### **Future Australian Electricity Generation Costs - A Review of CSIRO's GenCost 2021-22 Report**

**David Carland**

September 2022

Figure 11. Ratio of battery and VRE generation capacity (GW) required to achieve energy balancing for modelled shares of energy (GWh) delivered by VRE

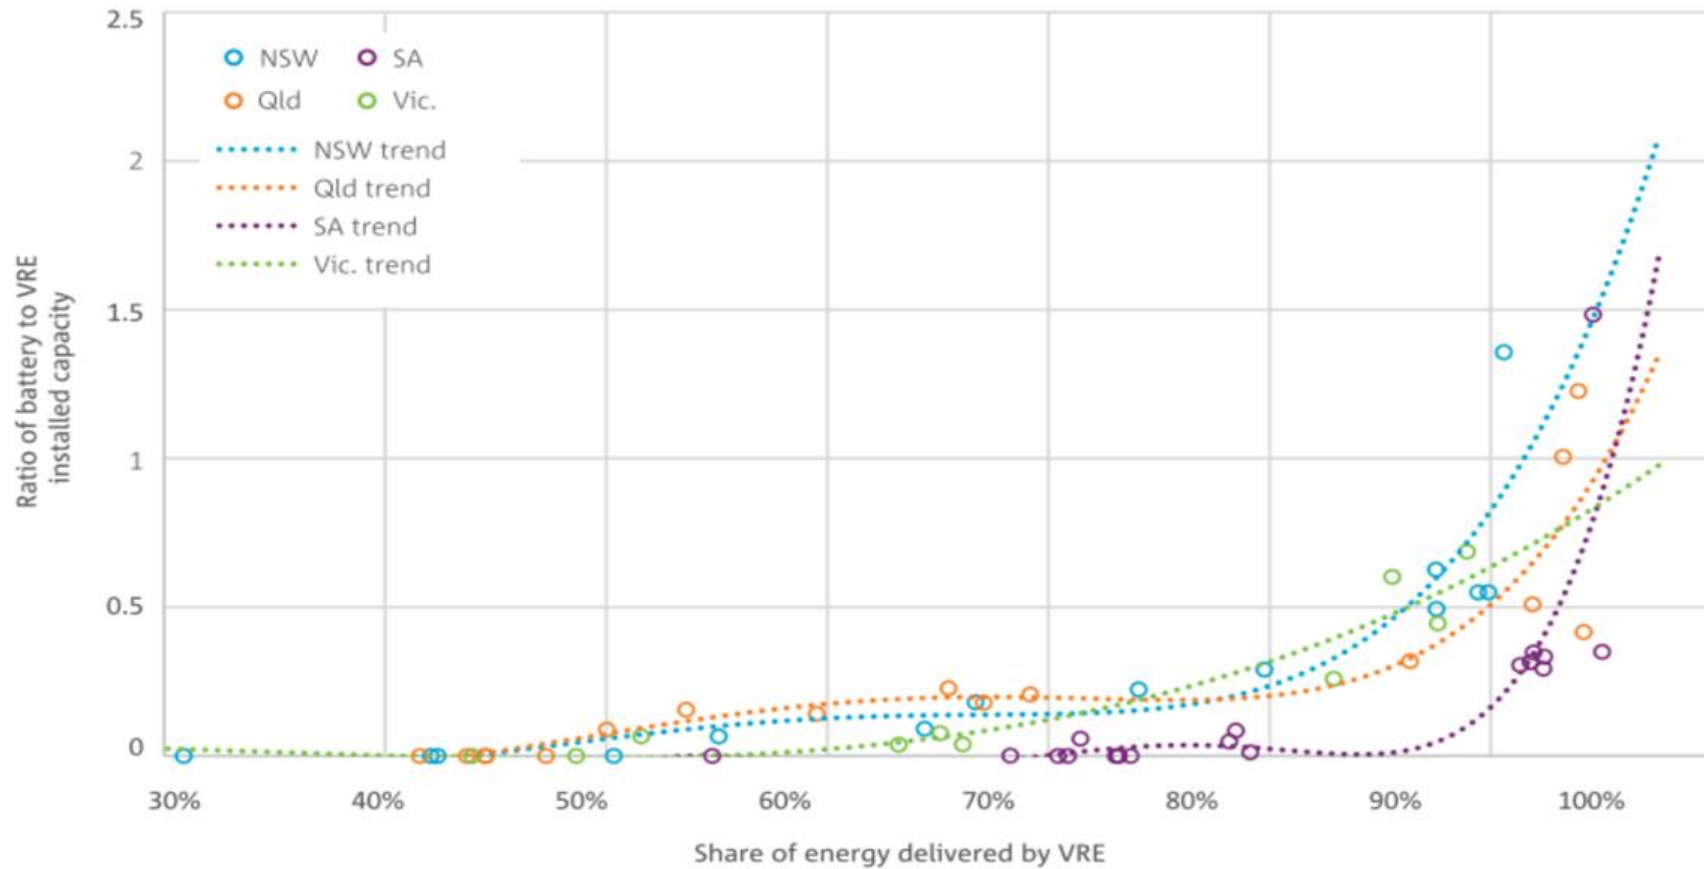
Appendix 3 reproduces Figure 11 of the CSIRO 2017 Roadmap which depicts the relationship between the VRE Share and the Firming Ratio in the NEM regions which increases exponentially as the VRE Share increases. Half-hourly modelling was used to derive these estimates in order to capture the rapid swings in VRE generation due to weather variability.
